manual change transmittal

NO. TM99-1

TITLE	APPROVED	DATE ISSUED 1-15-99
Traffic Manual	Kim Nystrom	PAGE 1 OF 1
SUBJECT AREA	ISSUING UNIT	
Chapter 7, Traffic Safety Systems	Traffic Operations	
SUPERSEDES Chapter 7 - Traffic Safety Systems, 11-1996, Pages 7-1 through 7-27	DISTRIBUTION All Manual Holders

CHAPTER 7 TRAFFIC SAFETY SYSTEMS

Figure 7-7
FREEWAY MEDIAN BARRIER STUDY WARRANTS

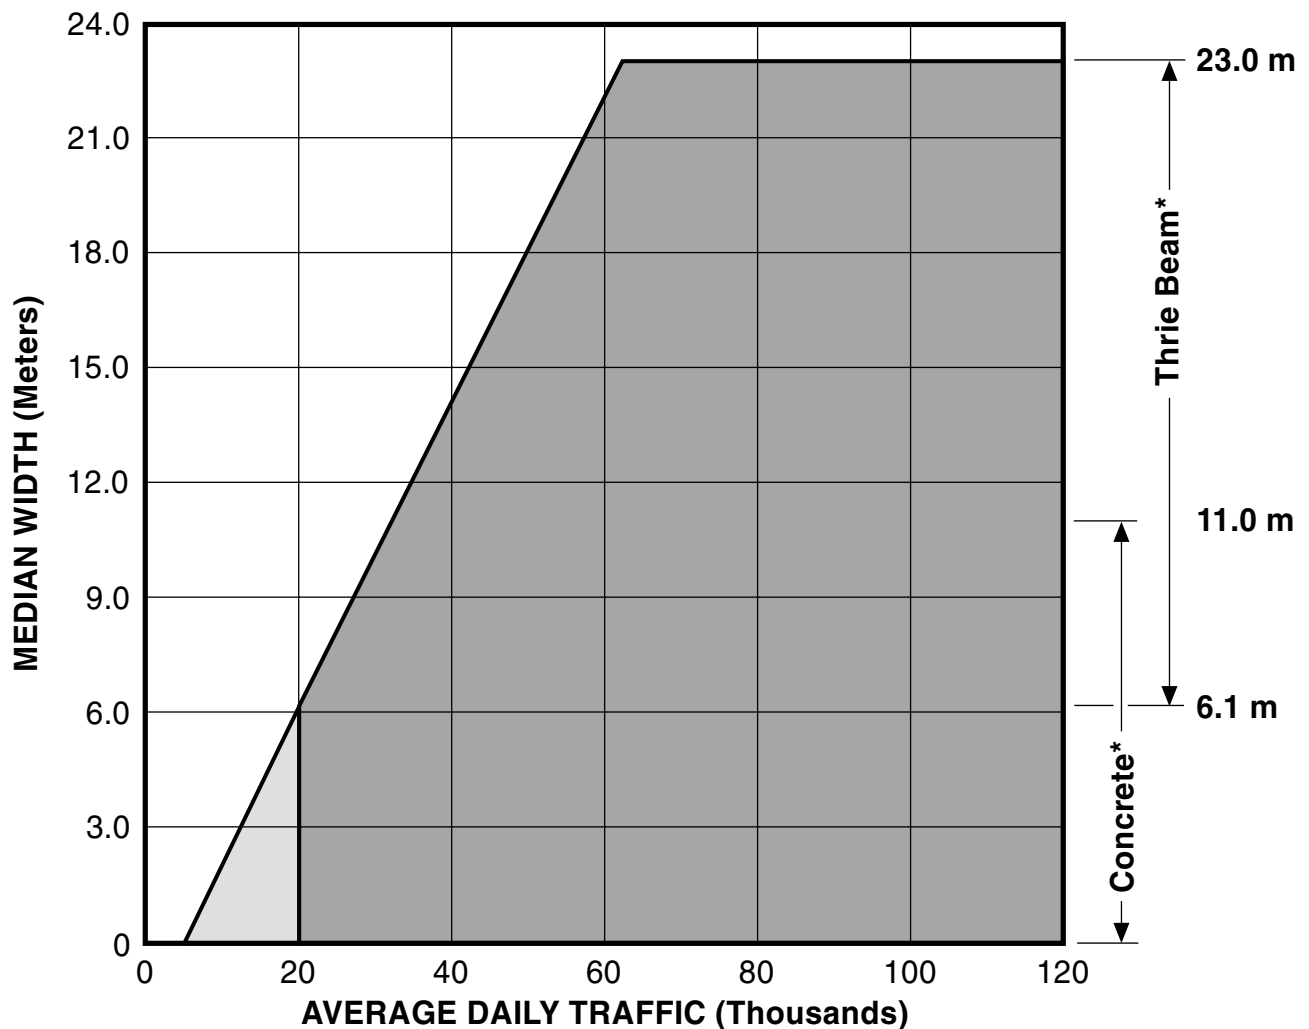
- Section 7-04.3 This section is renamed Study Warrants, warrants are now referred to as study warrants, the median width is increased to 23 meters and reference to a developing accident history is removed.
- Section 7-04.4 The guidelines for the installation of median barriers is rewritten.
- Section 7-04.6 The guidelines for Planted Medians is rewritten and guidelines for Adding Lanes in the Median is added.
- Figure 7-7 Freeway Median Barrier Study Warrants is revised to reflect current policy and the increase of the median barrier width.

- A. **Freeways.** The median barrier study warrants shown in Figure 7-7 have been developed through extensive study of freeway cross-median accidents. The need for a barrier should be considered on freeways whenever these study warrants are met and an accident history is developing. Any decision to install or not to install a barrier where study warrants are met should be thoroughly documented.
